Replacement of 2203102 with 2203101

Textar aims to streamline the designation from 2203102 to 2203101.

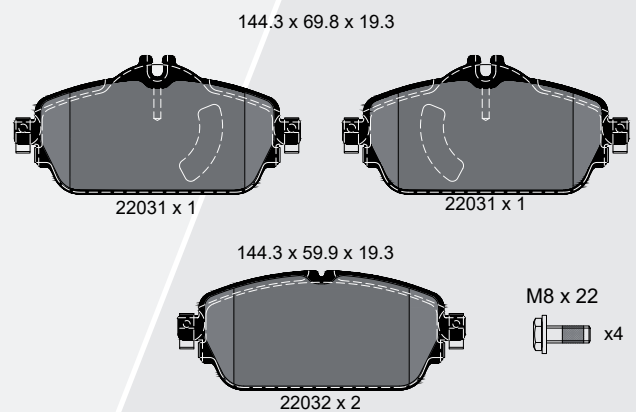
Given the identical outer dimensions of the brake pads we can ensure seamless assembly and operation. The parts are differing by a cut out in the shim for 2203101 while the adhesive foil for the outer pads will disappear.

This consolidation extends coverage to a broader range of vehicles under a singular reference, namely 2203101 which align more closely to the OE specifications and therefore is able to cover applications of both part numbers.
